**Annual Overlay/Rehabilitation 2013-14
PROJECT NO. 2014.0050**

ADDENDUM NO. 1

April 14, 2014

ANNUAL OVERLAY /
REHABILITATION 2013-14
2010/2011 NEIGHBORHOOD TRAFFIC CALMING PROGRAM
SPEED CUSHION INSTALLATION
JUANA AVENUE & DURANT AVENUE

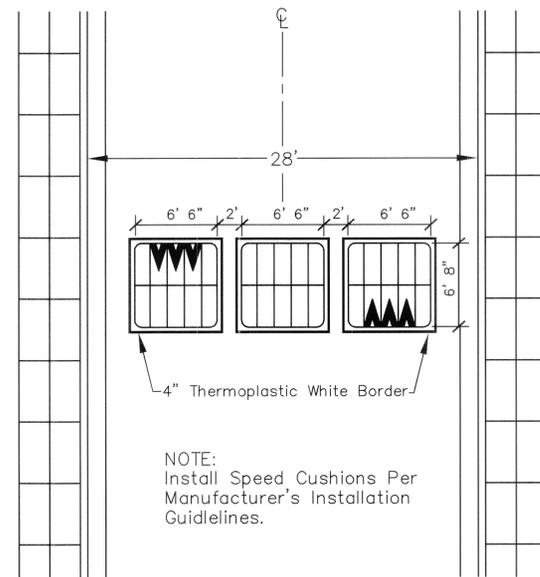
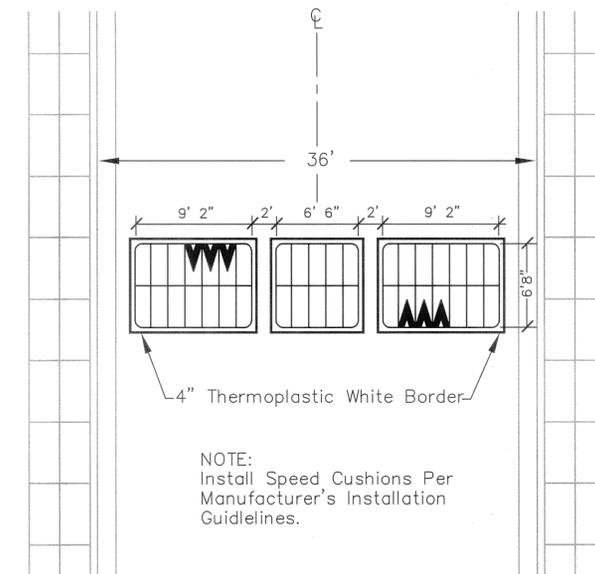
NO.	DATE	REVISION
1	4/11/14	ADDED SPEED CUSHIONS ON DURANT AVE
